APPLICATION FOR PERMISSION UNDER SECTION 16 OF THE TOWN PLANNING ORDINANCE (CAP.131)

For Official Use Only 請勿填寫此欄	Application No. 申請編號	A/YL-HTF/1158
	Date Received 收到日期	2 7 JUL 2023

Lots 505 RP (Part), 506 (Part), 507 (Part), 508, 509 (Part) and 510 (Part) in D.D. 128, Ha Tsuen, Yuen Long, New Territories

- The applicant seeks to apply for planning permission under Section 16 of the Town Planning Ordinance (Cap. 131) to use various lots in D.D. 128, Ha Tsuen, Yuen Long, New Territories (the Site) for 'Proposed Temporary Warehouse for Storage of Miscellaneous Goods for a Period of 3 Years and Associated Filling of Land'.

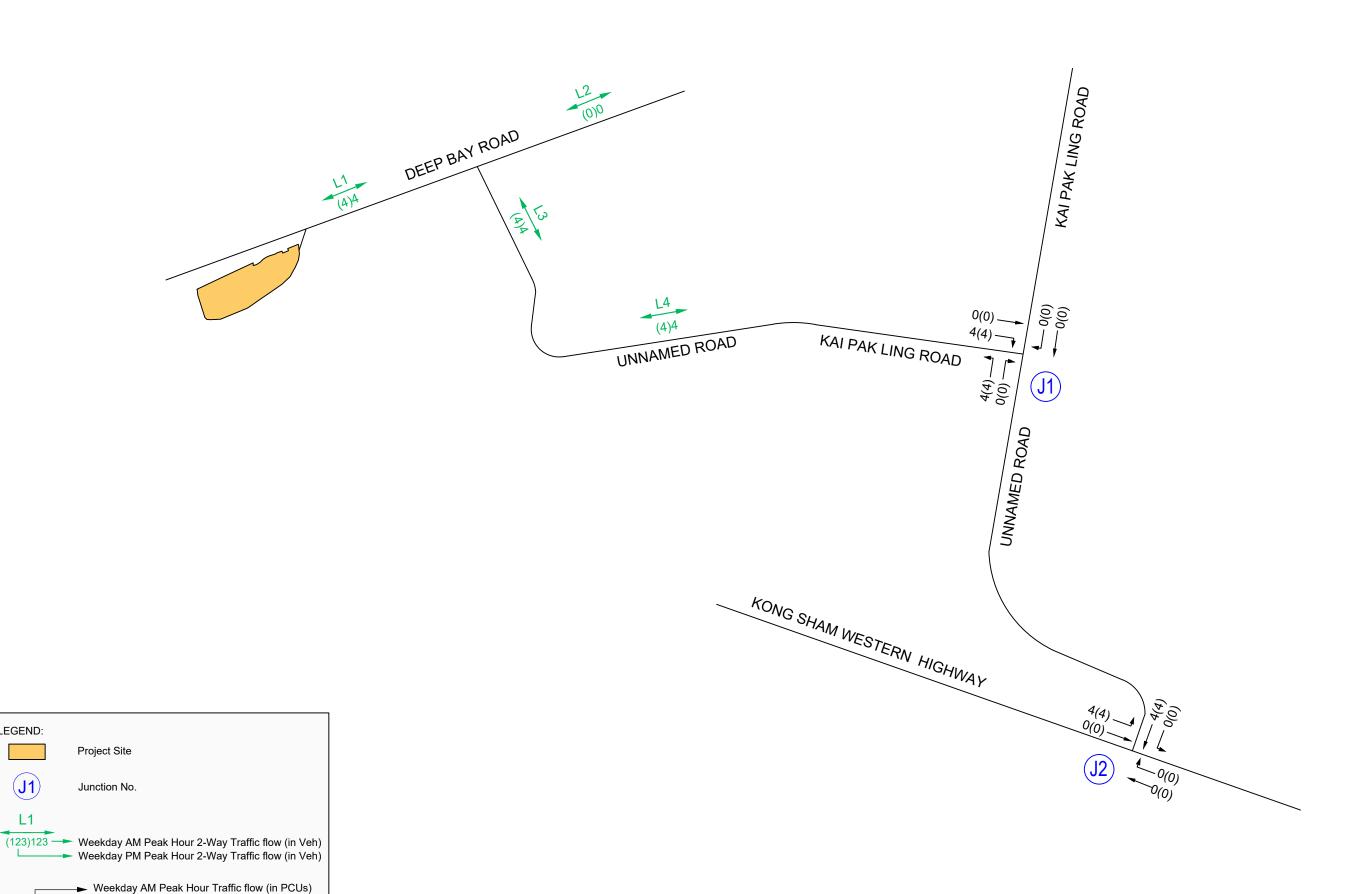
It is noted that the concerned Deep Bay Road is a single track road serving 2-way traffic. Based on site observation, vehicles (including MGV) are using various passing areas (with locations summarized in Figure 5-4 of the report (Annex III)) to facilitate the bypassing activities.

To further minimize the frequency of bypassing activities, vehicle delivery schedule will be developed and implemented during operation stage, so that traffic generated from the Site and traffic attracted to the Site will not occur concurrently.

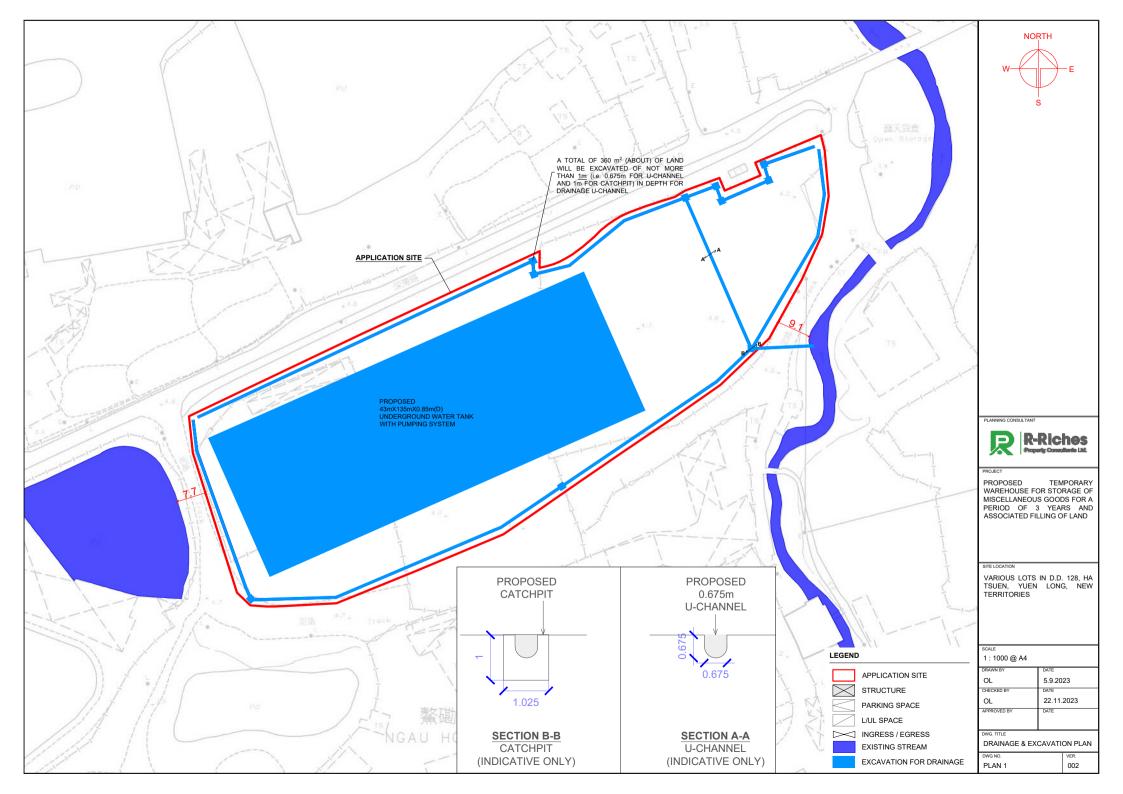
can it work.	catchpit CP5 and flow into the water tank through CP5. The U channel from CP5a to
		CP3 is removed from the proposed layout to
		avoid conflict with the building footprint. For
		the updated drainage layout, please kindly
		refer to the revised drawing no. Fig. 1 . The
		depth of the water tank is also reduced for
		the construction of the servicing and
		foundation.

(c)	The pump shall be connected to CP1 as	Noted. Sufficient space will be allowed to
	indicated. Please note that pressure	house the pump and the release chamber
	release chamber will be required but	which the proposed size of the storage tank
	CP1 is located underneath the building	should be not less than the volume proposed.
	footprint, please indicate how the	The pressure release chamber will be
	release chamber can be built. Please	submitted and designed in the drainage
	ensure sufficient space to be allowed	proposal stage.
	to house the pump and the release	
	chamber which the proposed size of	
	the storage tank should be not less	
	than the volume proposed.

(d)	Water will be pumped out from water	A pipe is designed between the water tank
	tank to CP1 and discharge to proposed	and CP1 for the discharge from the water
	600UC, however the 600UC only allow	tank. Please kindly refer to the revised layout
	for collecting runoff from the external	drawing no. Fig. 1.
	area but not the discharge from the	
	water tank, please clarify.	
	mater tarmy predate diamy.
